CHANGE NOTICE

Effective Date: DECEMBER 13, 2011
Log Number: CN-04-431
Subject: CONVEYOR DOGS PN 13515.00
Model Affected: EST-44

CONVEYOR BAR DOGS

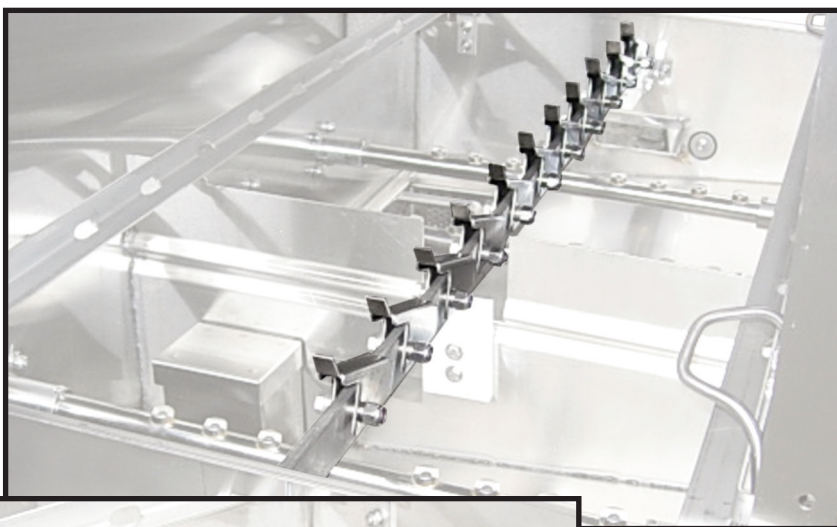
CMA has changed the quantity of conveyor dogs on the EST-44 from (5) to (11) dogs. This will make the EST-44 more compatible with the variety of dish rack brands offered in the warewashing industry. The flow of dish racks through the machine will be more consistent with our published rating of 243 racks per hour for all brands of dish racks.
